### **REMARKS**

Claims 15 to 21 are now pending in the application. Applicants reserve the right to file one or more divisional applications with the unelected claims.

Fig. 1

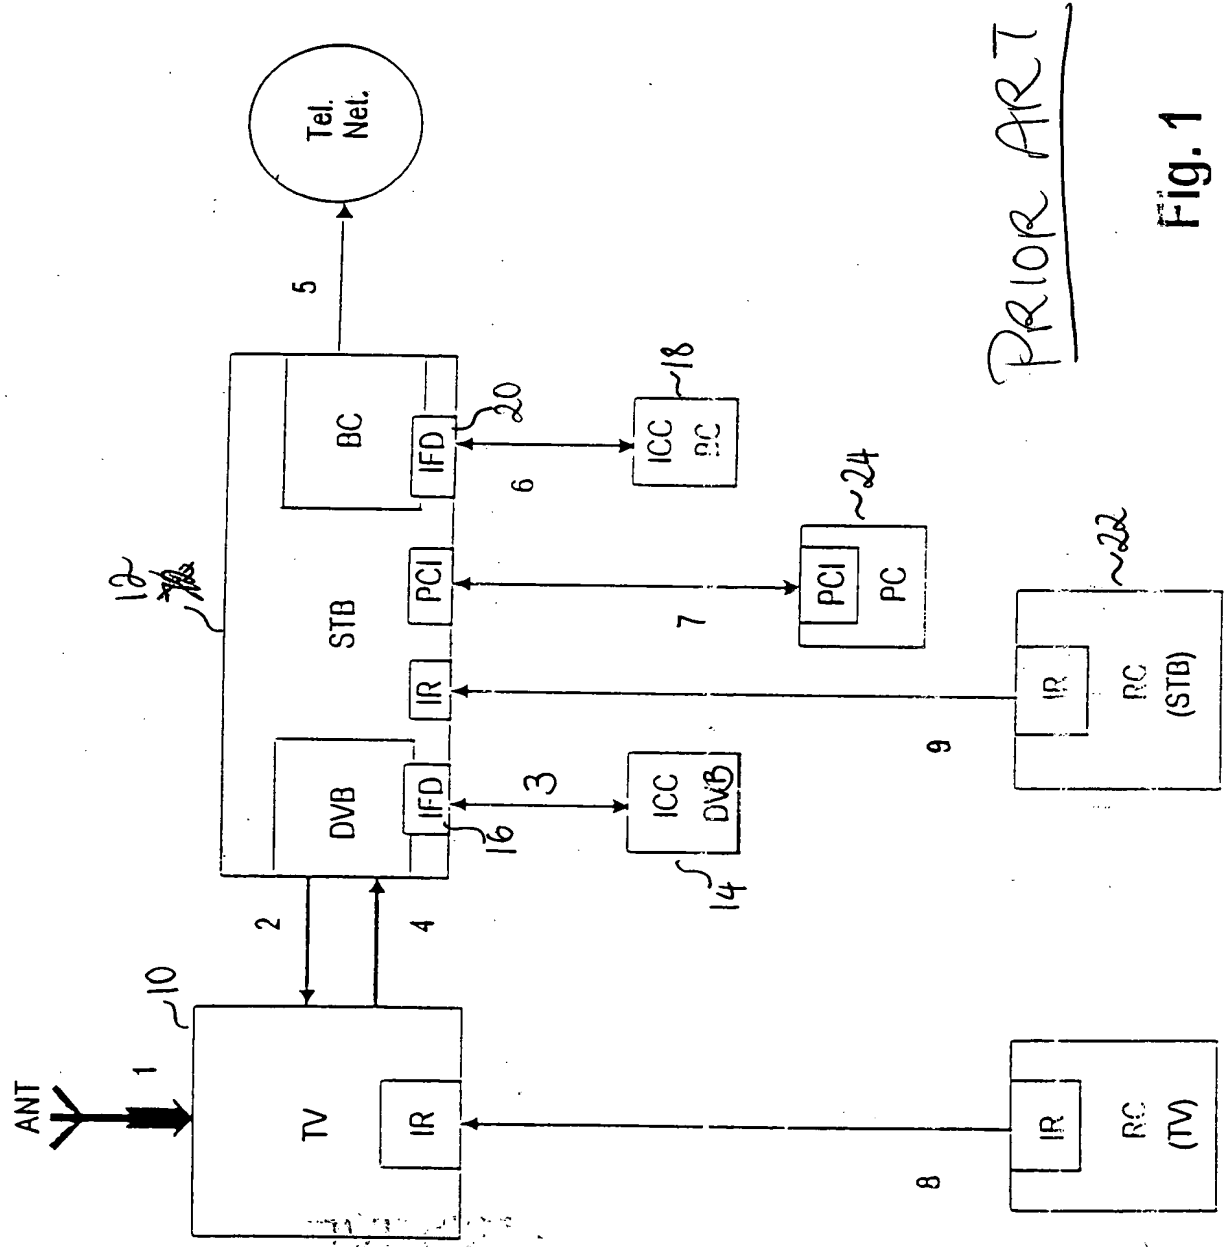
The Drawings were objected to for failing to comply with 37 CFR 1.84(p)(5). Specifically, Fig. 1 was objected to for STB being labeled 72, and no heading of "Prior Art." Applications have amended Fig. 1 so that STB is labeled 12 and there is a heading of "Prior Art" as suggested by the Examiner. No new matter has been added. Specifically, Fig. 2, was objected to for RCU being labeled 34 while it was referred to as 42 in the Specification. For this and other typographical errors, Fig. 2 has been amended, and, the Specification has been amended so that the description of Fig. 2 is consistent with the drawing of Fig. 2. No new matter has been added. Accordingly, Applicants submit that the Drawings have been amended in accordance with the Examiner's requests and all objections to the Drawings have been overcome. Withdrawal of the objections to the Drawings is respectfully requested.

PRIOR ART
